Addendum No. 2
London-Laurel Economic
Development Authority London,
Laurel County, KY
Speculative Building for Greta Lane
Bid Date: June 26, 2023
Issue Date: June 21, 2023

The following additions, deletions, changes or revisions are issued herewith and become a part of the Project Documents. Addendum No. 2 consists of seven (7) 8.5x11 pages, and seven (7) 24x36 sheets.

ME-2

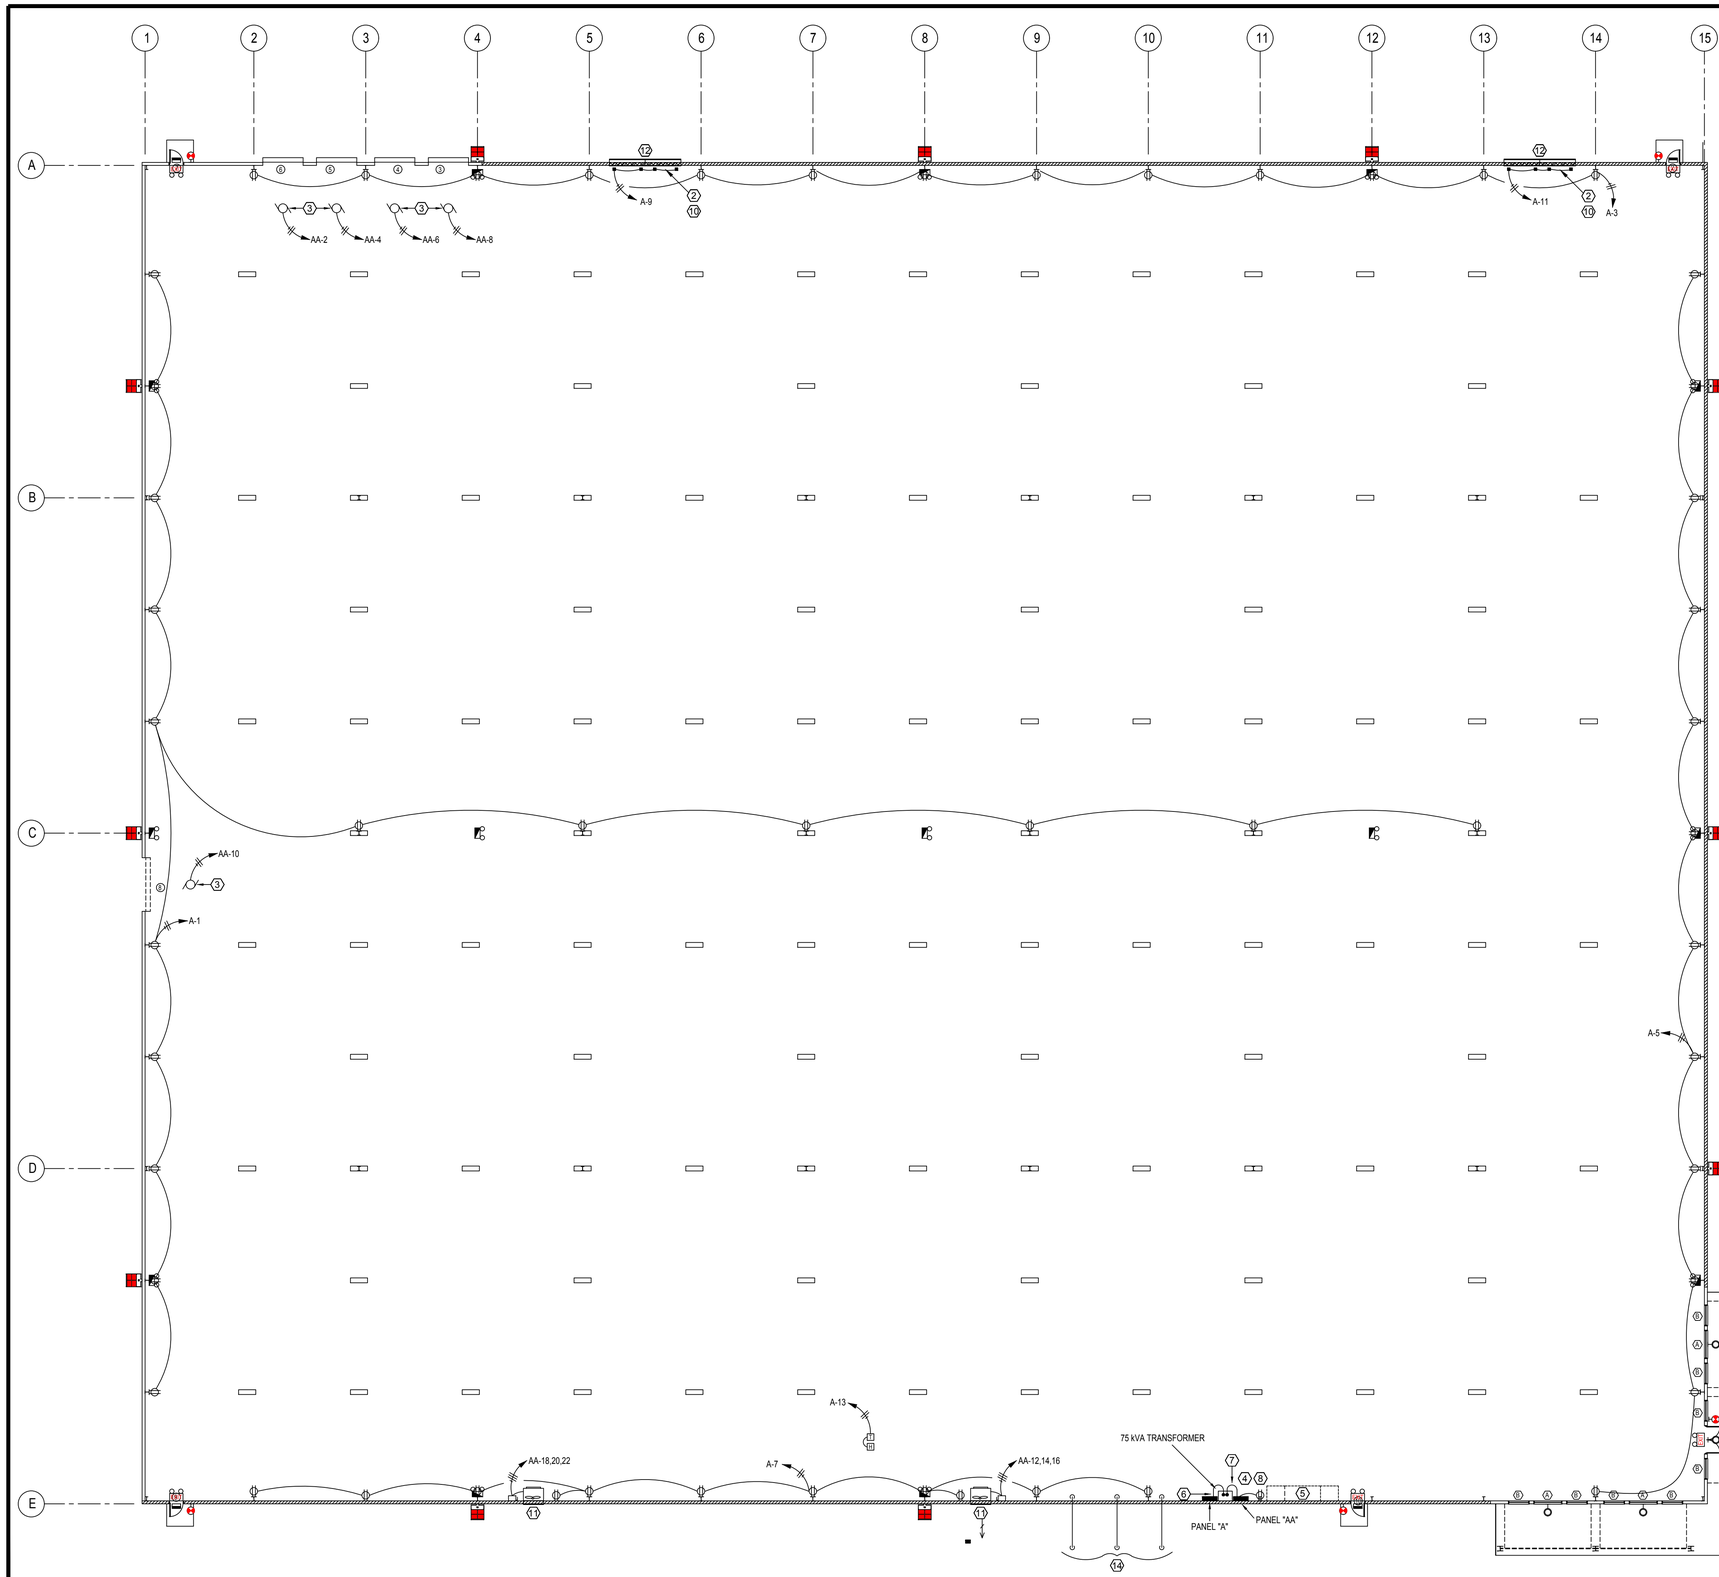
Item 23 – Refer to sheet M-2 for locations and quantities of louvers and exhaust fans. Refer to sheet M-3 for descriptions (make/model) of the louvers and exhaust fans.

Reference Panel A: Change AIC rating from 10,000 to 14,000,

Reference Panel AA: Change AIC rating from 14,000 to 24,000.

Reference Panel AA: Add surge protection, 300 KA. Use SASD Type 1 suppression device.
